1. 7:00 P.M. Historic District Commission Regular Meeting

HDC Work Permit Staff Review

Property address: 629 N River

Proposed work: Installation of a small fence and accessory building (shed).

PHDC-20-0003

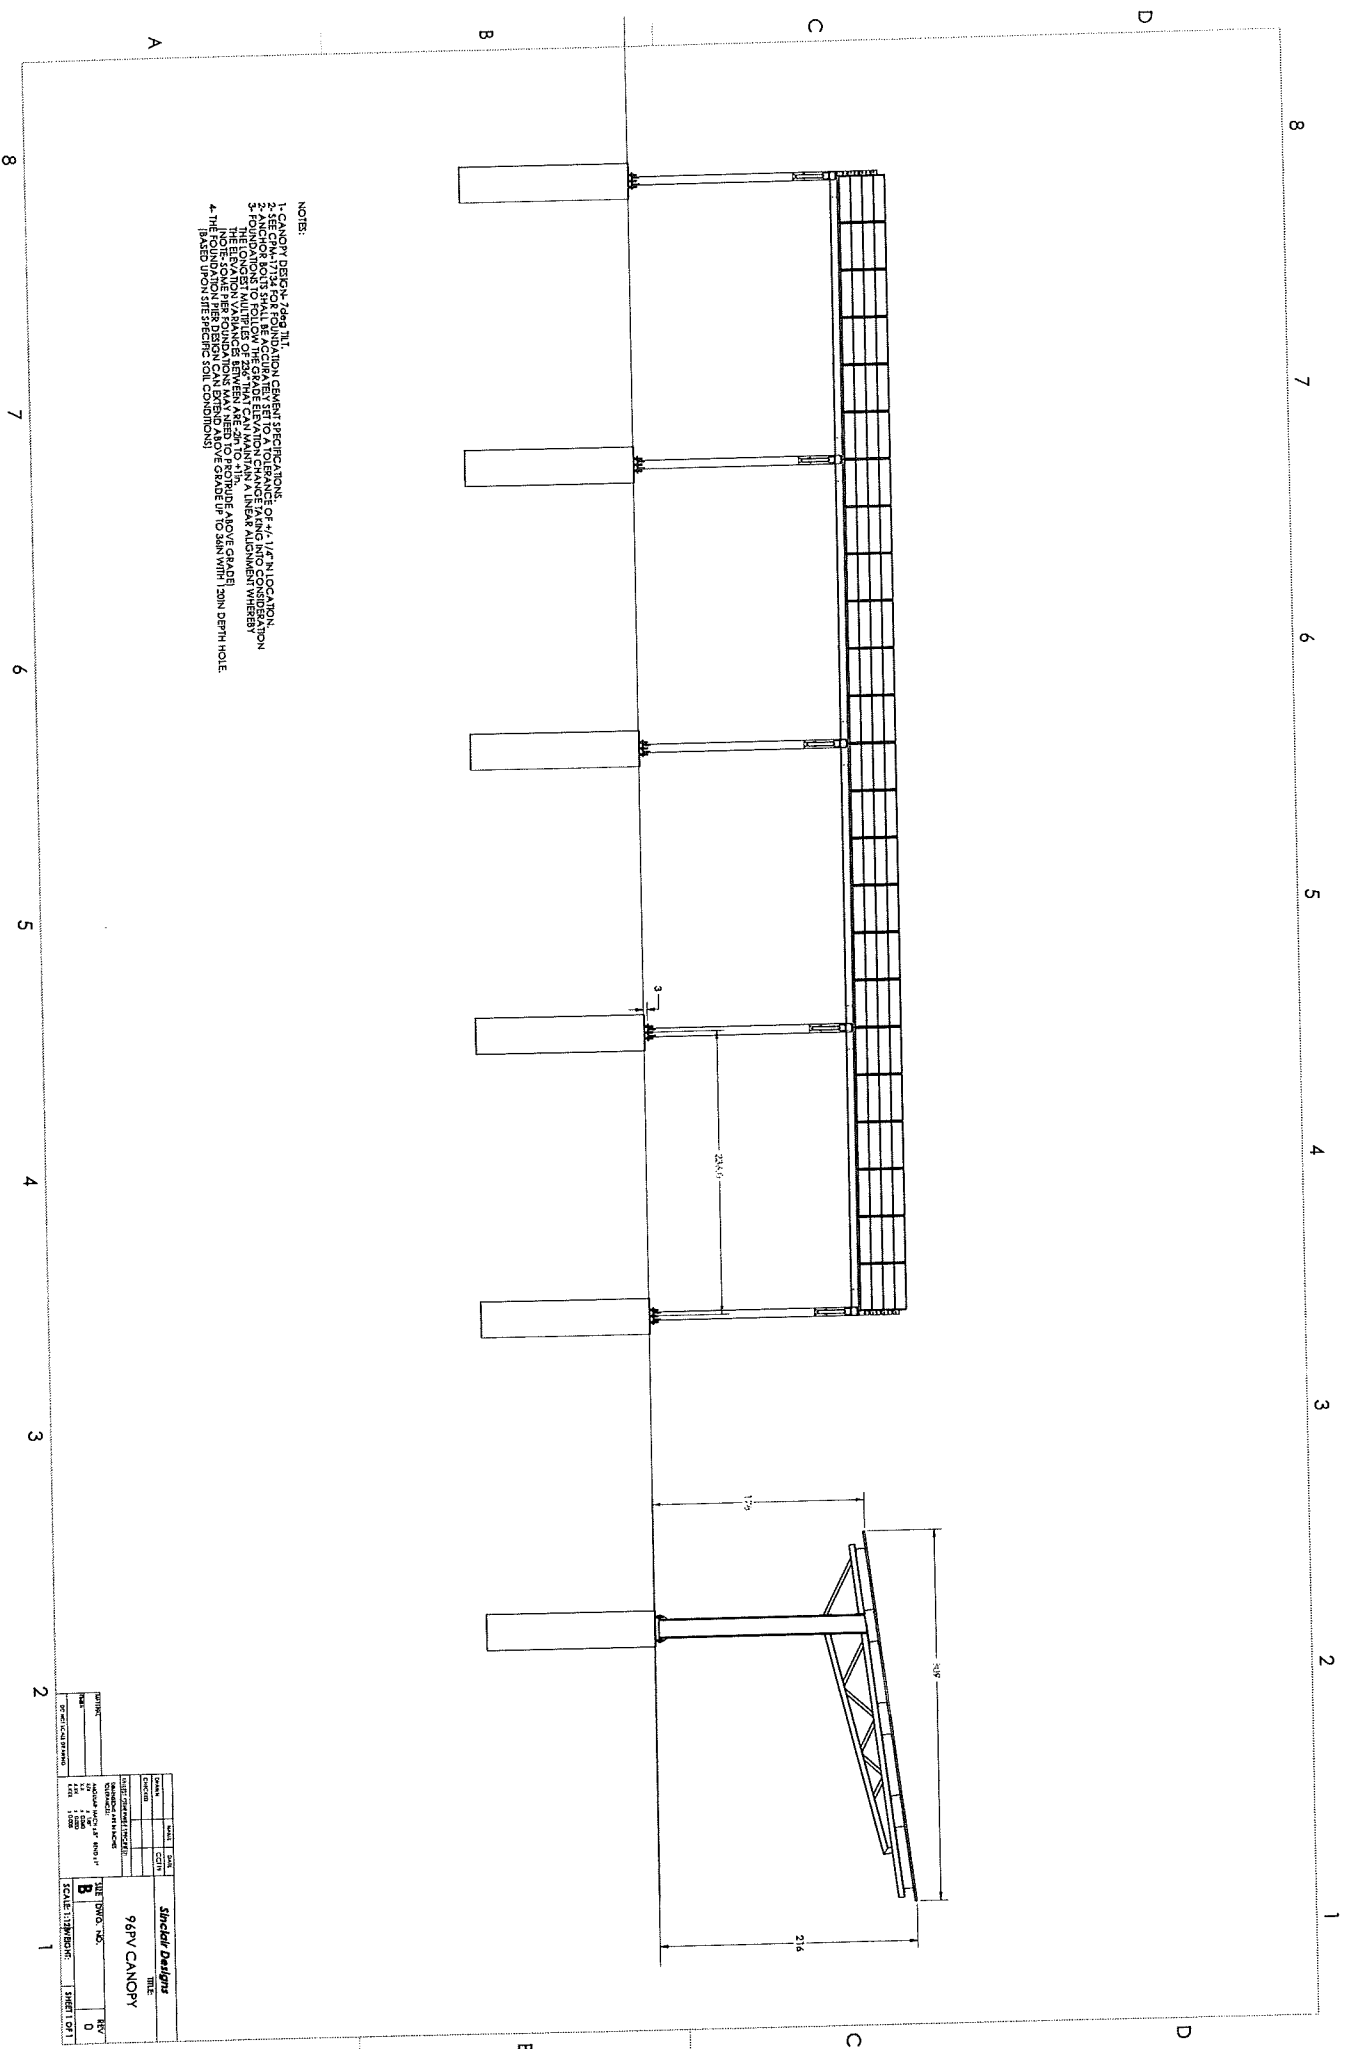
- b. There are plantings on the south side of the property, including Crimson Point Plums, and Snowcloud Serviceberry, but they are not designed to screen views.

6. The structure will be visible from East Cross Street.
 - a. According to the guidelines of the Alternative Energy Fact Sheet, if the location of solar panels can be seen from the street, then solar panels would not be approved in that location.
